**UNITED STATES ENVIRONMENTAL PROTECTION AGENCY
REGION III
1650 ARCH STREET
PHILADELPHIA, PENNSYLVANIA**

**FINAL DECISION AND RESPONSE TO
COMMENTS
ON SELECTION OF CORRECTIVE MEASURE
UNDER SECTION 3008(h) OF THE RESOURCE
CONSERVATION AND RECOVERY ACT**

**MARJOL BATTERY SITE
THROOP, PENNSYLVANIA**

DECEMBER 2000

EPA Figure 1

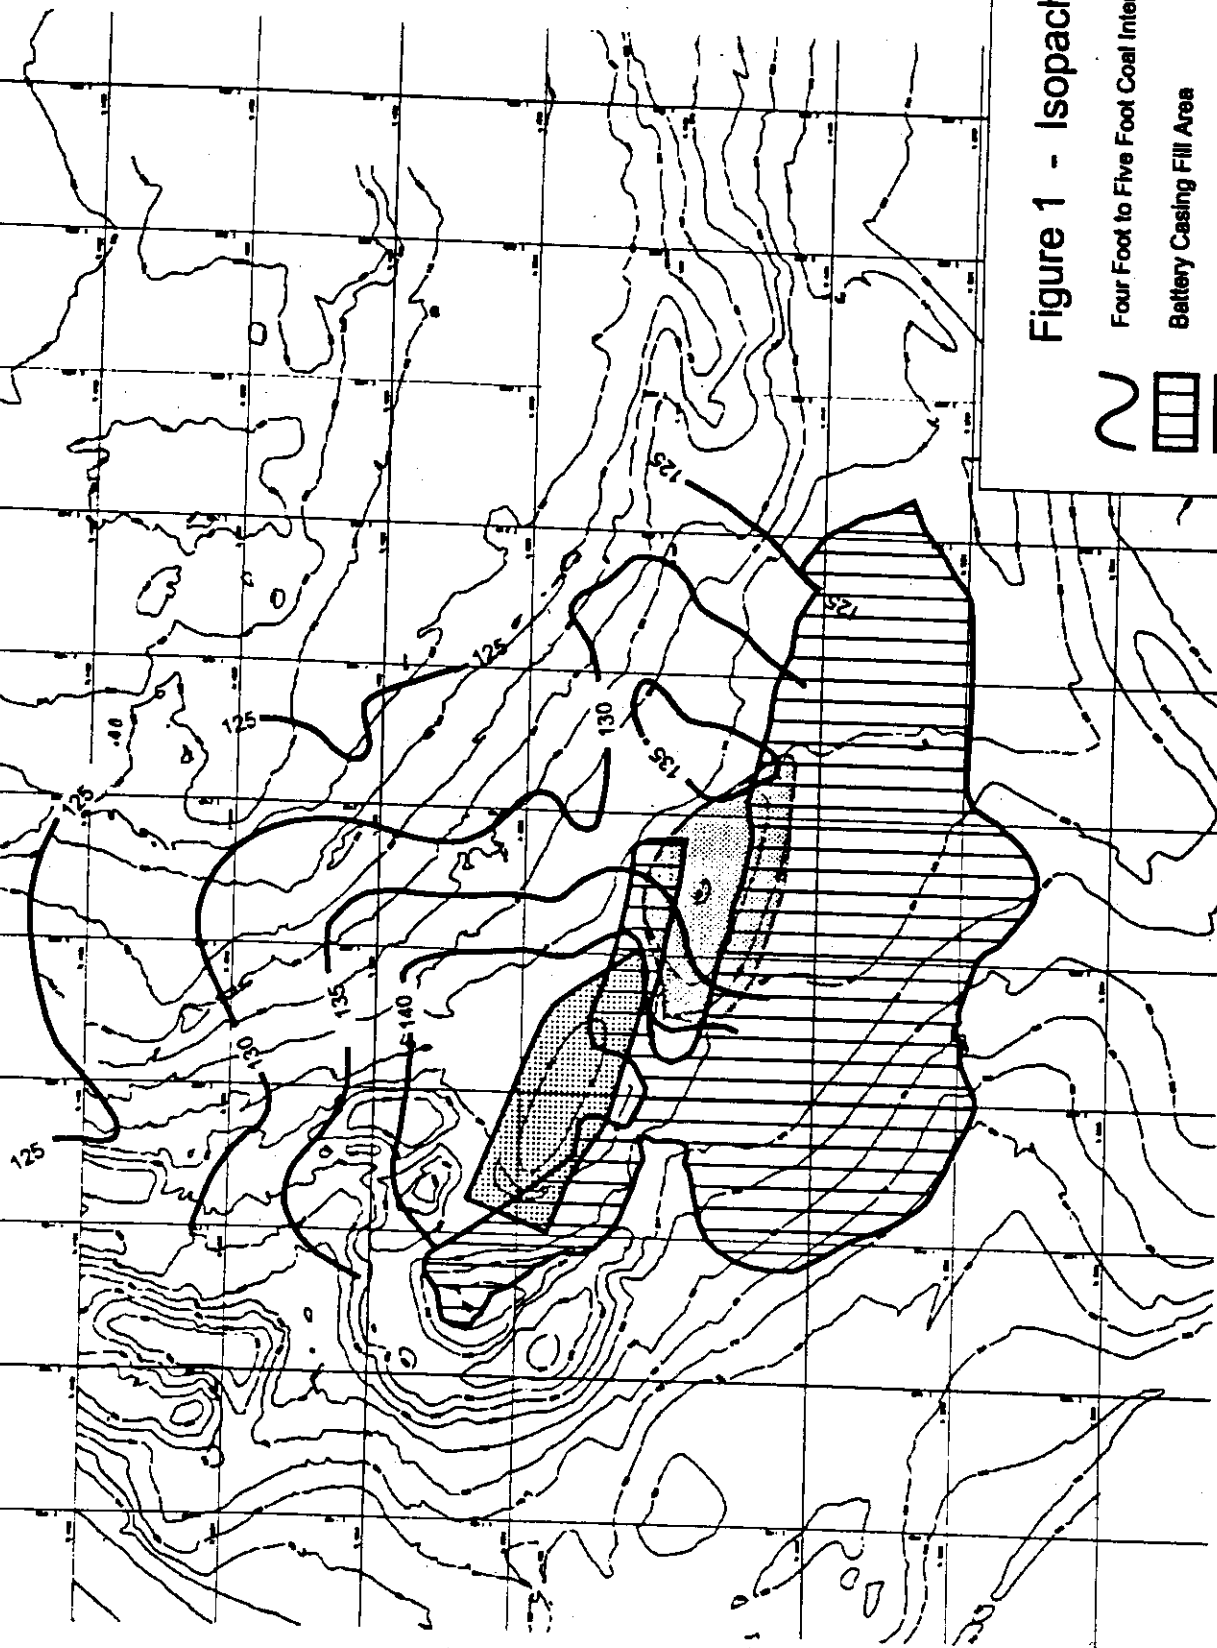
EPA Response: GF used a constant thickness of 140 feet above the floor of the Four Foot coal to determine the elevation of the Five Foot coal seam. Using a constant thickness for an interval can help predict where a seam might lie, but thickness intervals can vary naturally. There is very little boring data available to characterize naturally occurring thickness variations between these two seams. GF states that they used the mine map information to establish interval thicknesses. GF developed two structure contour maps based on elevations from OSM mining maps for the Five Foot (Figure 3) and the Four Foot (Figure 4) coal seams. As stated above in response to Section 1.3.2, EPA overlay these two maps, and created an isopach map based on the elevation difference between these two maps. That isopach map indicates that the interval between the Five Foot and Four Foot coal seams ranges between 122' and 144'.
